REMARKS/ARGUMENTS

Serial Number 10/768,781 Resp to Office Action dated May 11, 2005 Resp dated Aug. 11, 2005

FIG. 1

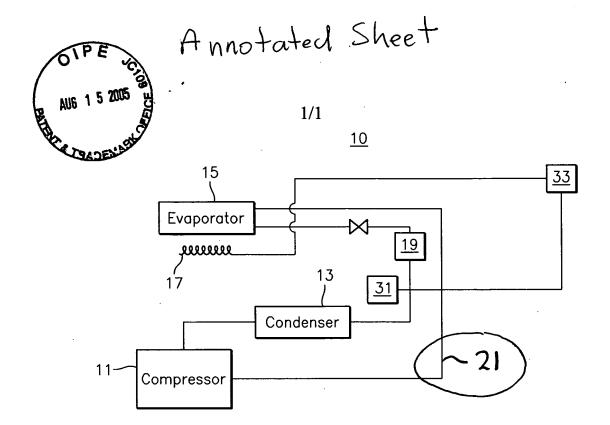
In the aforesaid action, the Examiner objected to the drawings, allowed claims 1-11, and rejected claims 12-14 over prior art. The examiner also pointed out an error in dependency in connection with claim 13.

In connection with the object to the drawings, drawing corrections have been submitted which add reference numeral 21 to Figure 1. No new matter has been added and this is believed to resolve this issue.
